ENVIRONMENTAL REVIEW TEAM REPORT

HIGH MEADOWS WATERTOWN, CT

**HIGH MEADOWS
WATERTOWN, CT
MARCH 1984**

Figure 2 SITE PLAN A- CLUSTER PROPOSAL

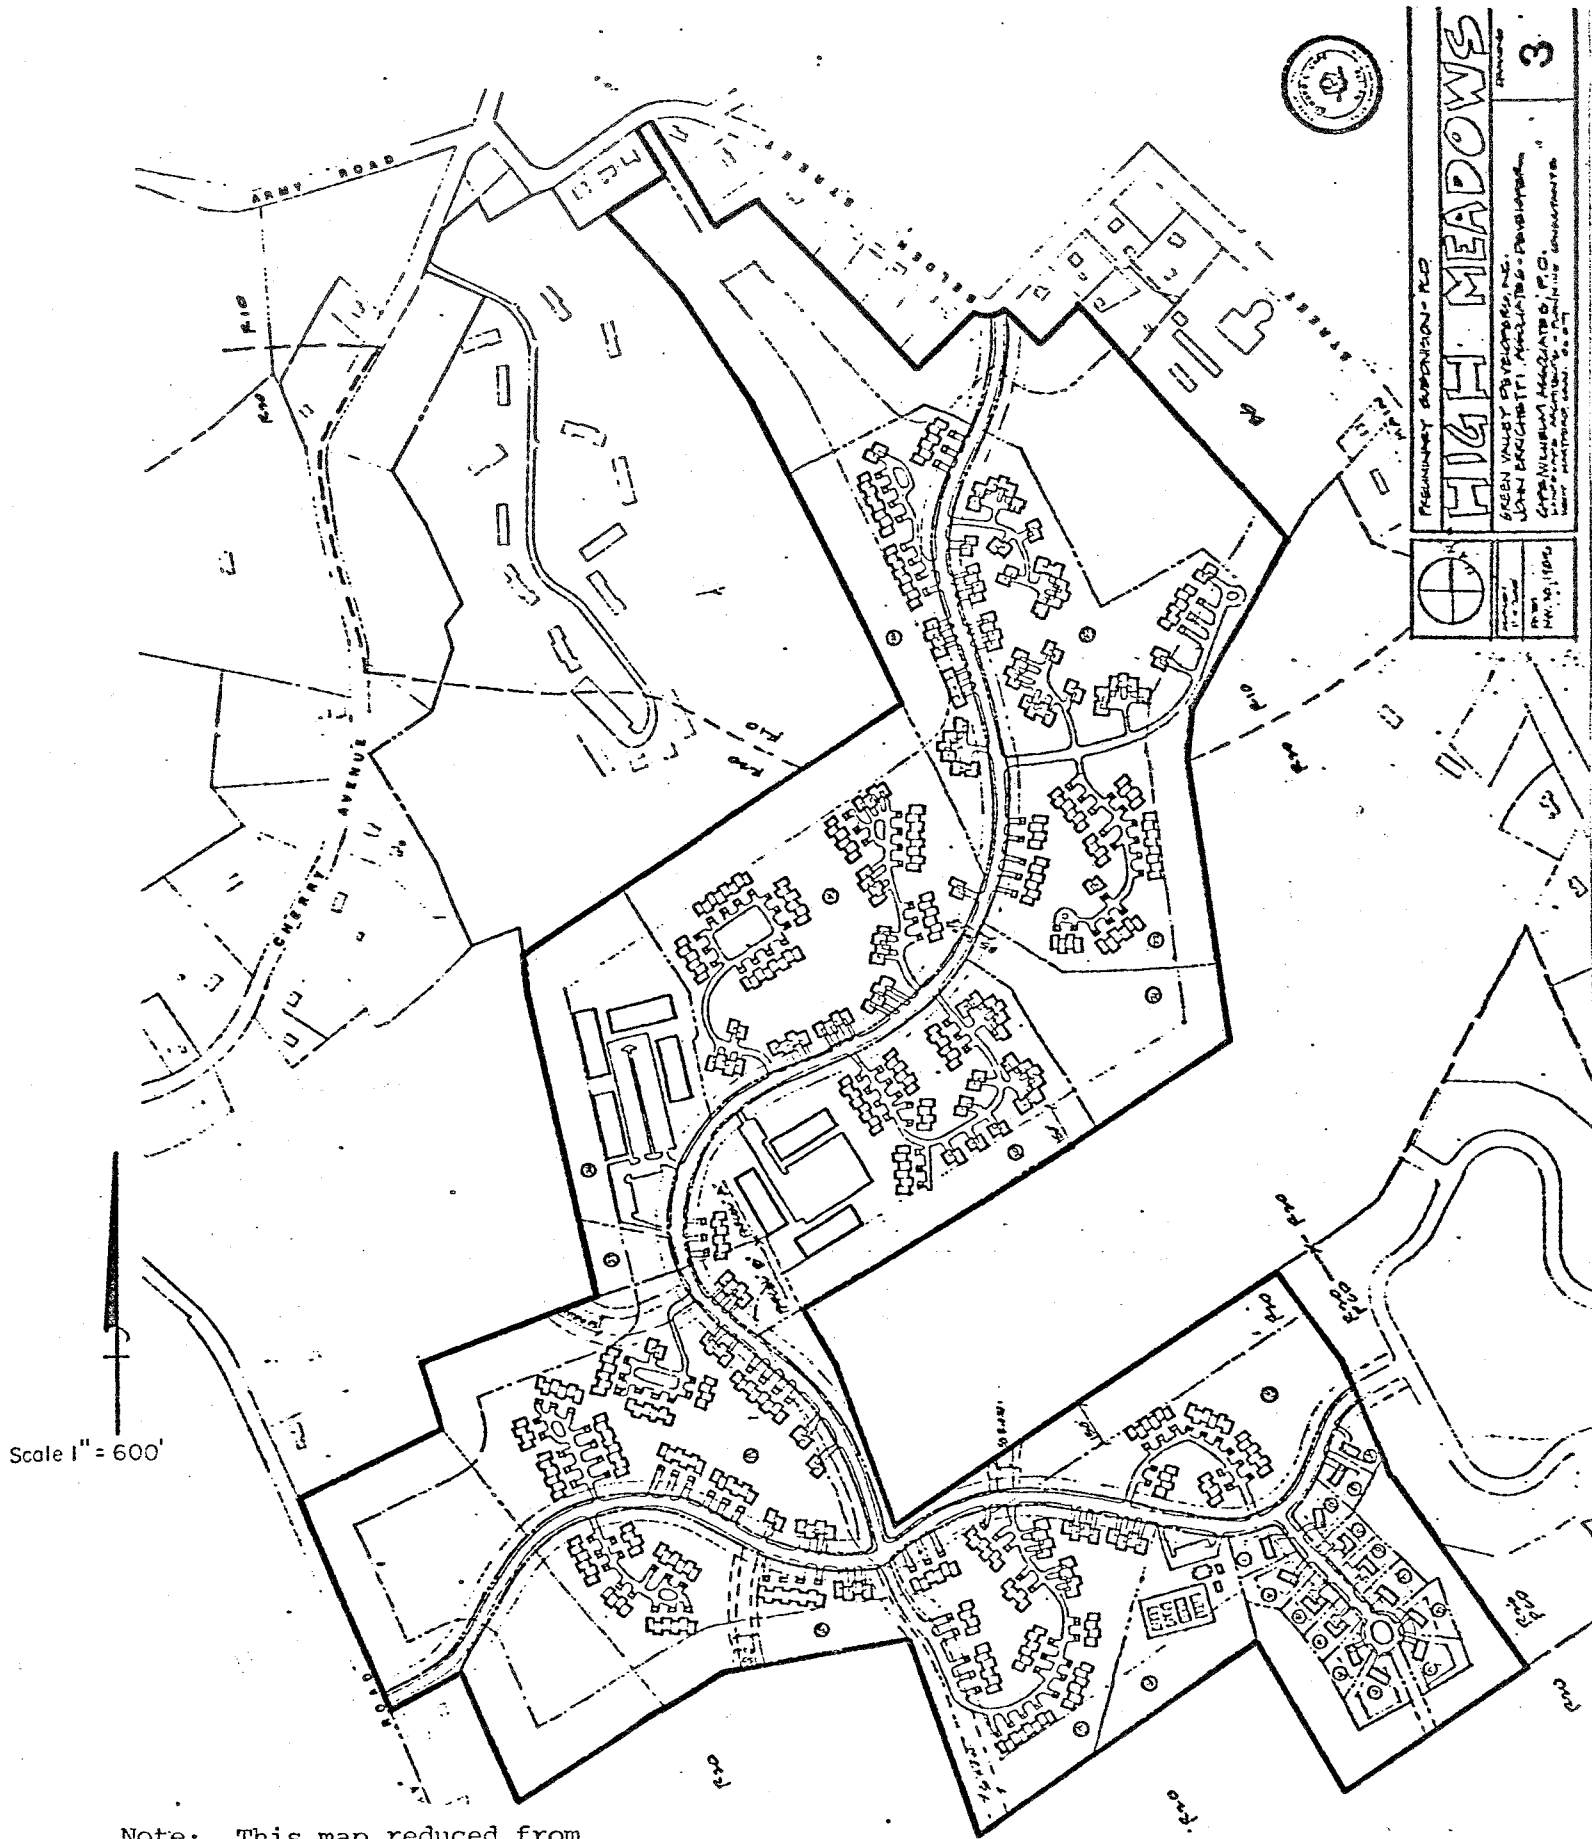
The "conventional plan" proposes houselots and more roadway within the 100 year floodway and wetland soils than does the "cluster proposal". The proposed entrance road off of Middlebury Road would have much less wetland and 100 year floodway to cross and contend with if it were located + 650' north of its proposed entranceway.

In general, there are more lots shown within or partly within inland wetland soils on the "conventional plan" than on the "cluster proposal". Both

The site has many areas of open gentle slopes along with slopes as steep as 40%. In an apparent effort to maximize the number of lots and/or units for both plans A and B (see Figures 2 and 3), many buildings and roads have been proposed on slopes in excess of 15%, and one road on the condominium plan goes across a 25% slope. Plan "A" places housing lots on this slope while Plan "B" takes a road across its steepest part. In the opinion of the Team's Planner, consideration should be given to restricting housing types to townhouses and single family units, and the road network should be revised to take houses and paved areas off of the steepest portions of the site.

SITE PLAN B- CONVENTIONAL PLAN

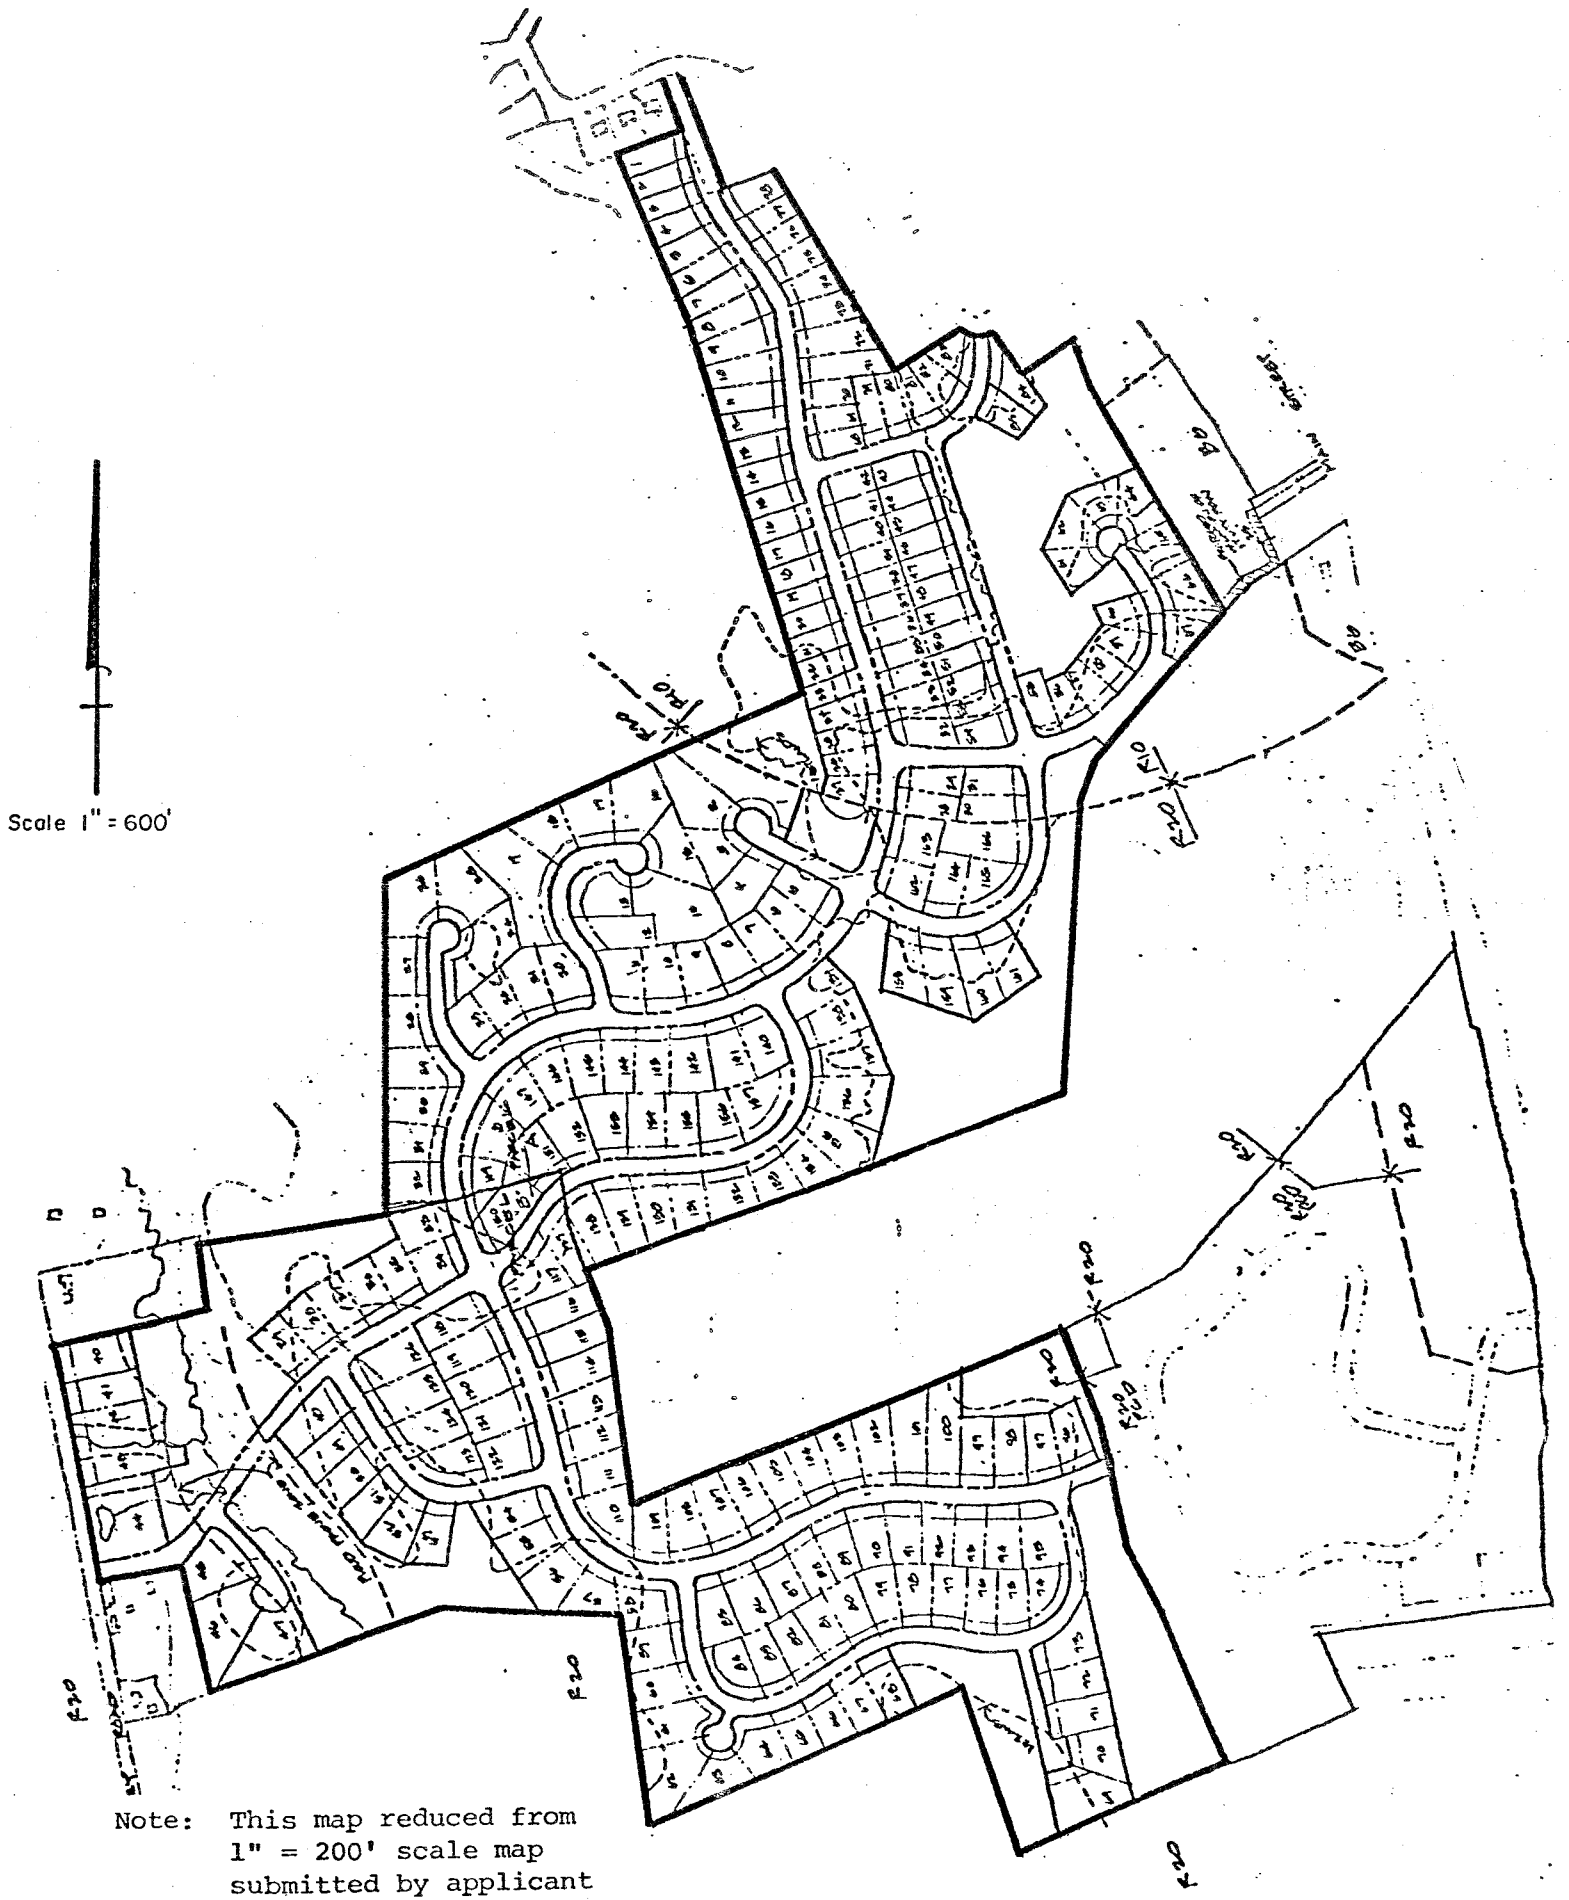
On the other hand, if the parcel is developed under the conventional subdivision plan, it appears that the geology and topography in some areas (i.e., wetland areas, rock outcrop areas, steep slopes) would not be conducive to the high density development presently proposed.

The "conventional plan" proposes very little open space land other than wetland soil areas.

Figure 6 DRAINAGE BOUNDARY MAP

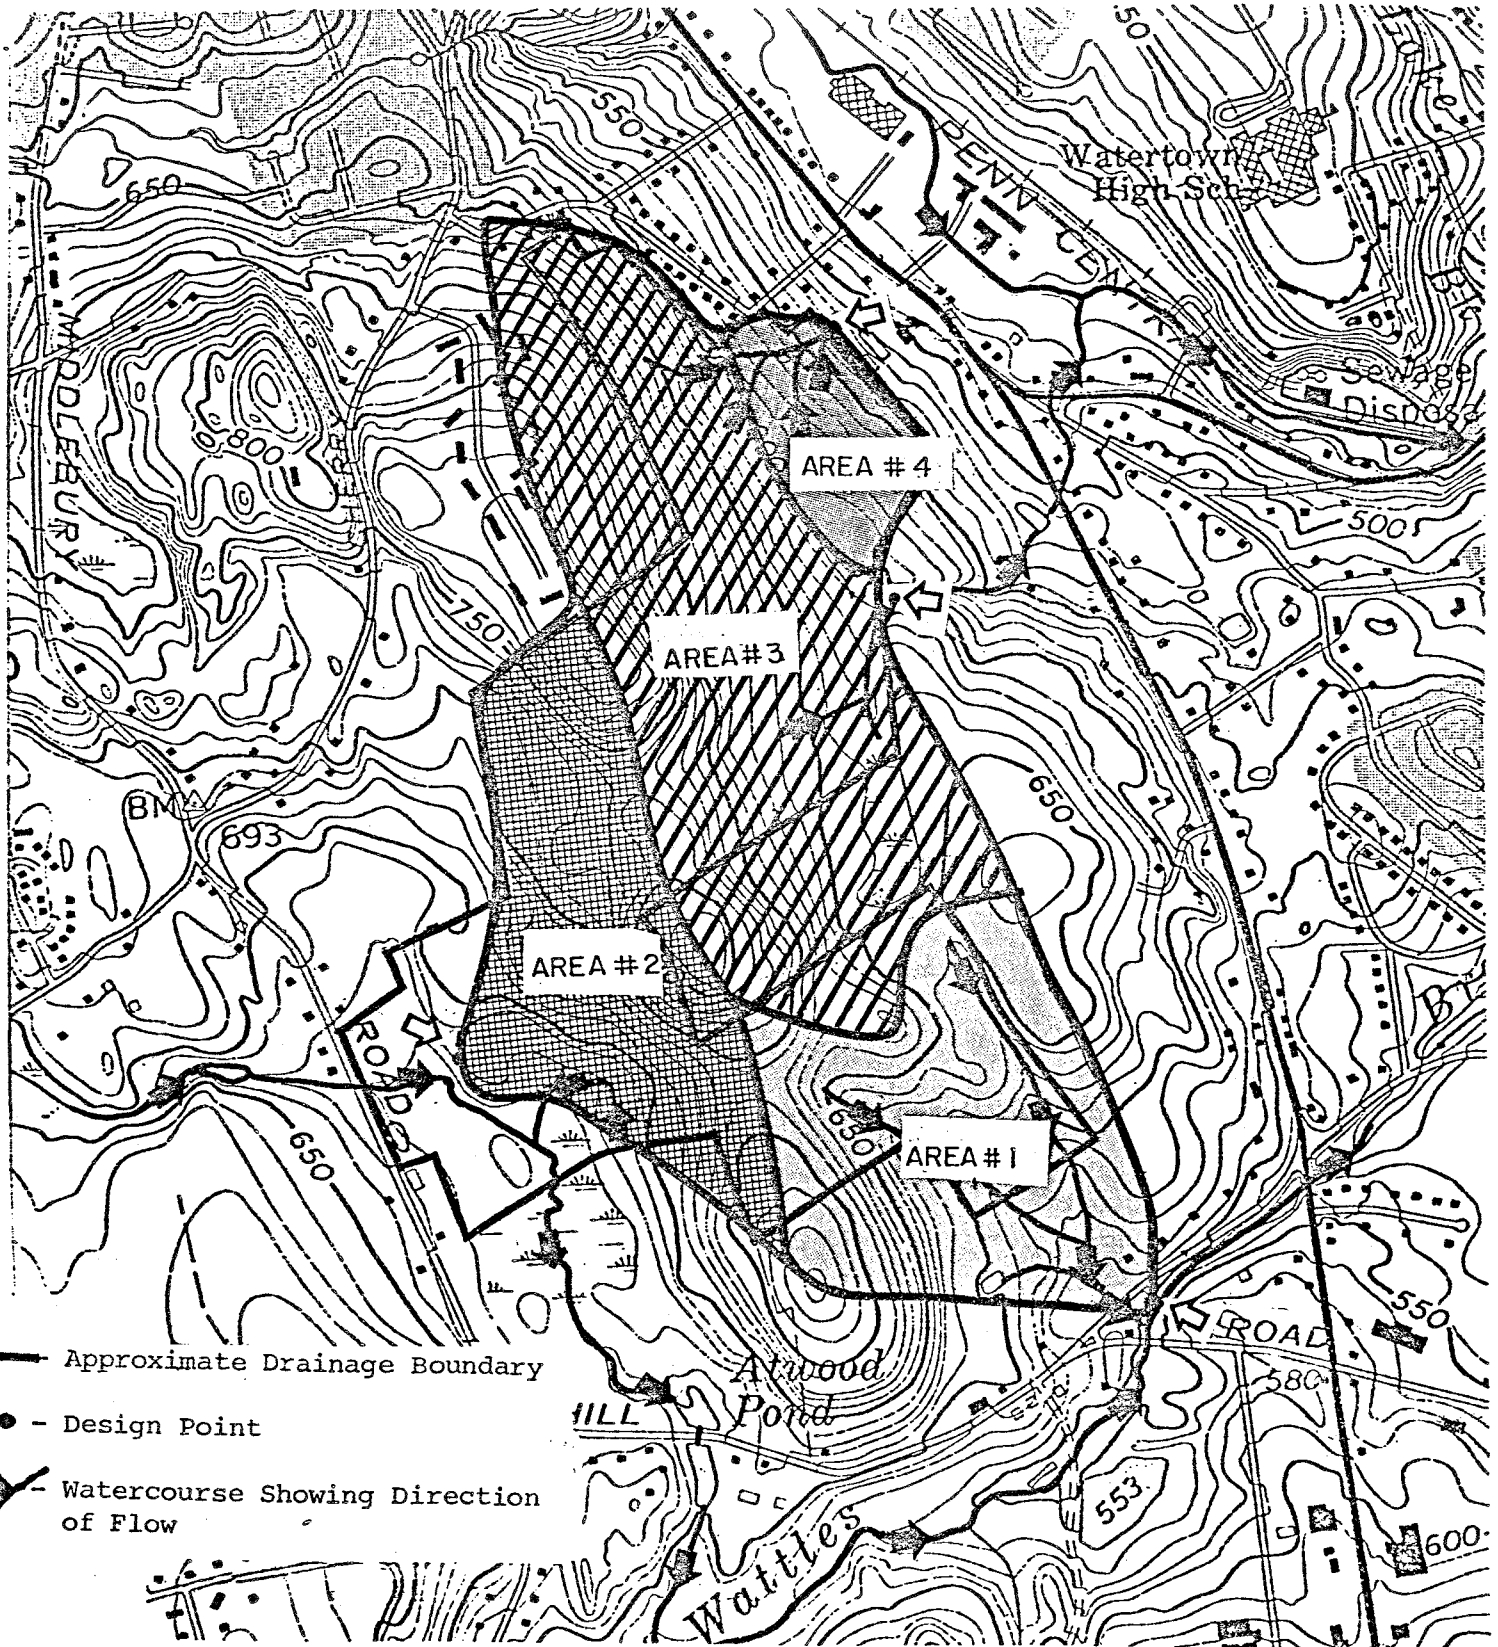
For the purposes of analyzing the runoff changes likely to occur under either proposal, drainage areas within the parcel were broken down into four areas. These areas are delineated in Figure 6. It is assumed that the project engineer for the development will break the drainage areas down similarly when addressing pre- and post runoff changes, although he or she may address it altogether differently. Each drainage area is based upon a particular point of outflow and shows all the land from which surface runoff ultimately reaches that point.

It should be noted that the drainage areas and design points shown in Figure 6 do not, for the most part, follow natural conditions. Rather these drainage areas and design points were drawn based on how runoff is presumed to be collected and discharged with implementation of the project.

project engineer. It is possible that increased runoff from this area could be compensated for when designing detention basins for Drainage Area 2 (see Figure 6).

Figure 8 CRITICAL SOIL AREAS

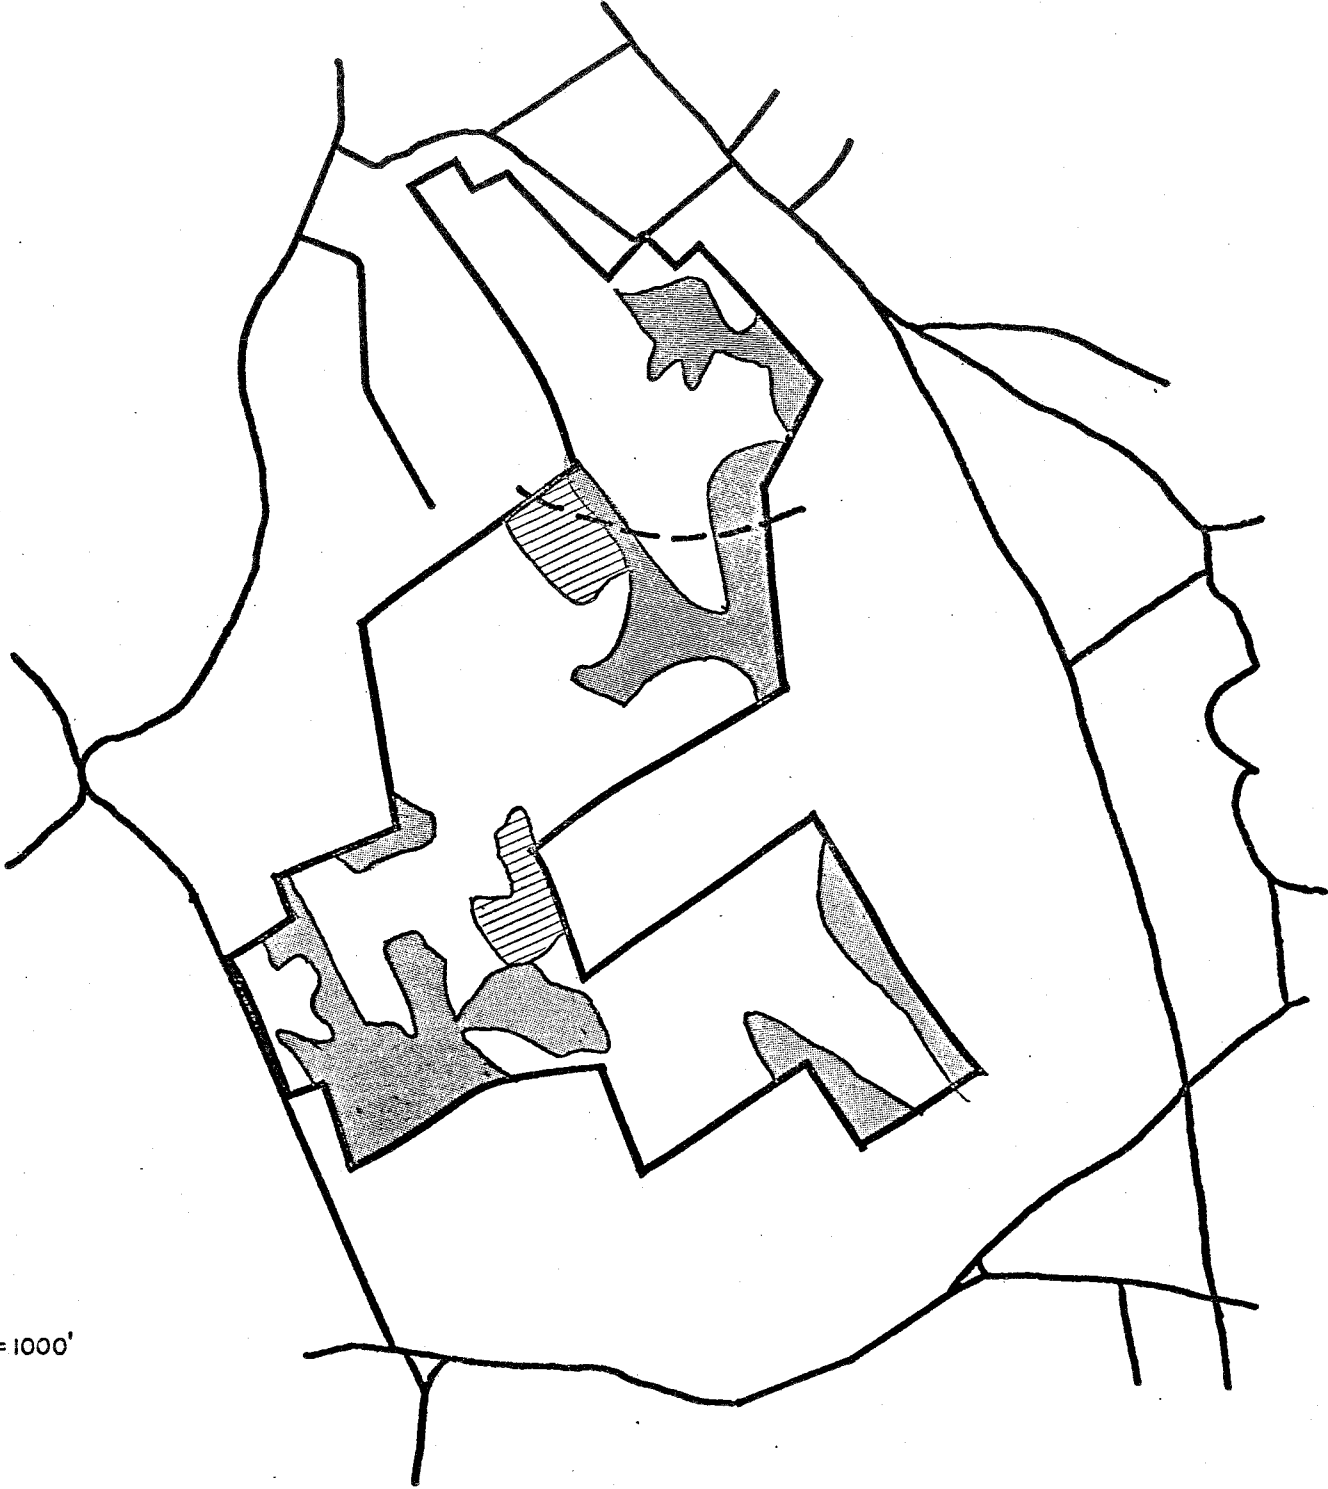
Figure 8 of this report indicates the most limited soil areas for development purposes. Serious consideration should be given to avoiding these areas in project design.
